Land at Coventry Stadium, Brandon

Designer's Response to Stage 1 RSA of Proposed Internal Site Layout

Road Safety Audit Stage 1 3 May 2022

Figure 2: Proposed All-weather pitch

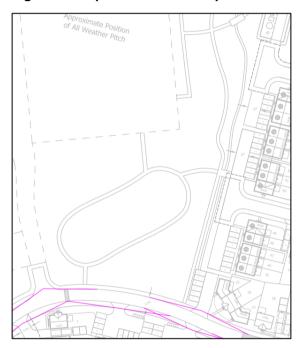
An all-weather pitch is proposed as part of the development for which the Audit Team do not have the full details in relation to the parking. The Audit Team is concern that should insufficient parking be provided, vehicles may park on the residential roads and potentially within the turning heads. Parking within the turning heads may restrict access to driveways and prevent road users from being able to turn which may result in inappropriate turning movements increasing the potential for conflict. Significant numbers parking on-street may restrict the free flow of traffic or should vehicles park partly on the footway, pedestrians may be forced into the carriageway, increasing the risk of conflict.

Provide sufficient off-street parking for the all-weather pitch. Parking restrictions may be required, particularly within the turning heads.

2.6 The auditor's recommendation is accepted. The level of parking has been informed by discussions with potential operators and is considered to represent an appropriate level of parking to accommodate expected demand. Consequently, it is considered unlikely that overspill parking onto residential streets would occur in practice. It is proposed however that the demand for car parking associated with the all-weather pitch will be monitored and the need for further restrictions kept under review.

Site Layout

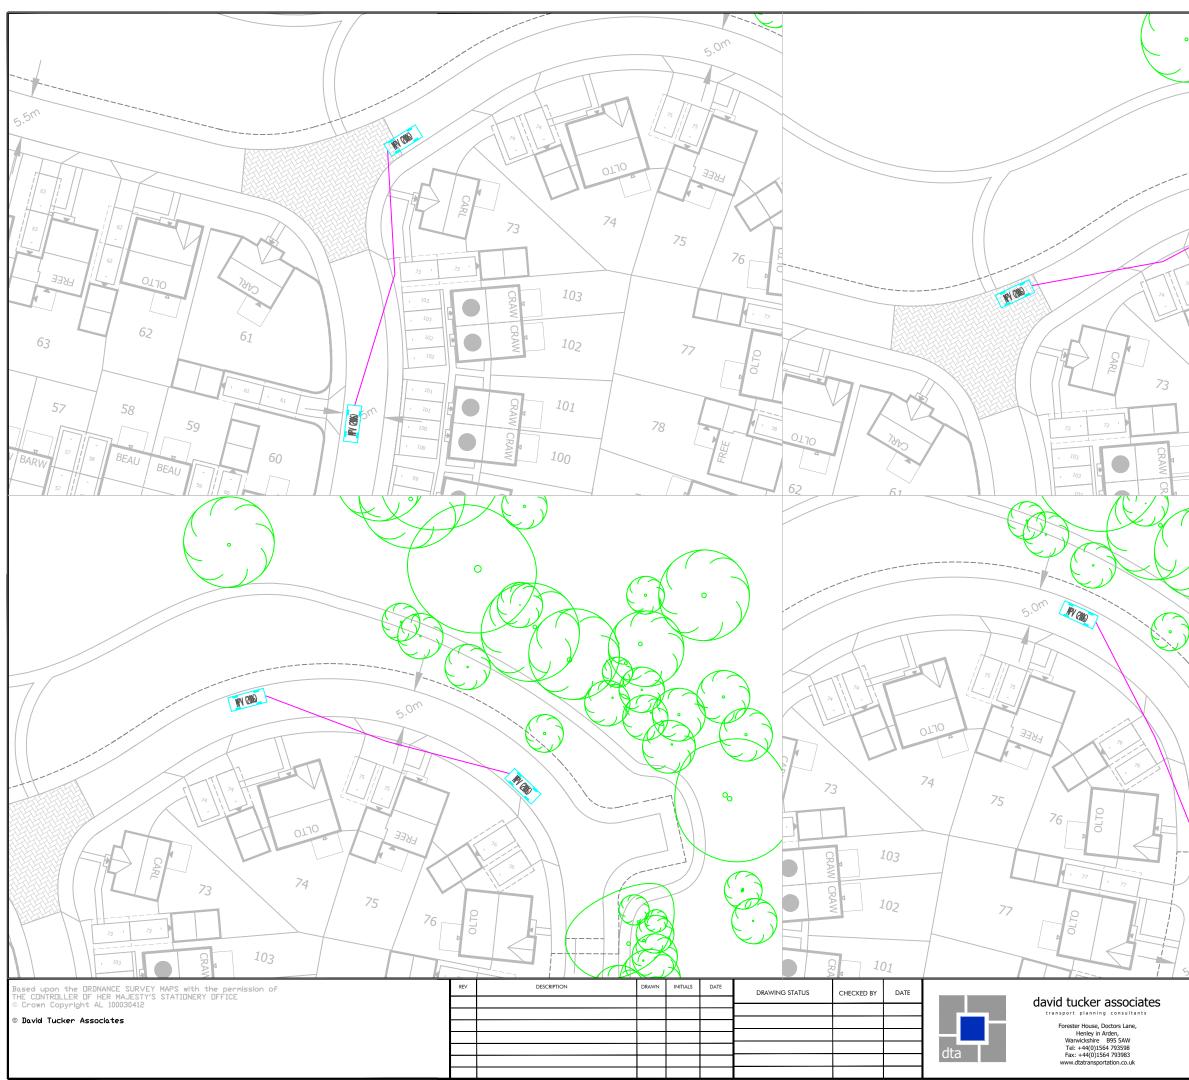
Summary: Lack of links between footways and footpaths may result in pedestrians walking on uneven ground leading to trips and falls.

A footpath is proposed to circulate the development, however there would appear to be only one connection (located on the northern side) which links to the footways within the development. It is likely that a development of this size will generate pedestrian movements between the footways within the development and the footpath outside of the development. A failure to provide appropriate links may result in pedestrians walking on uneven ground which may lead to trips and falls.

Provide suitable links between the footways within the development and footpaths that circulate the development.

2.1 The auditor's recommendation is accepted. In addition to connections being provided to the north, south and west, additional links have been shown to the east as set out on the revised site layout plan attached as **Appendix B**. These are located opposite plots 76 and 105.

| Rev | Amendments | Date |
|-----|--|----------|
| С | Footpath connections added. | 23.05.22 |
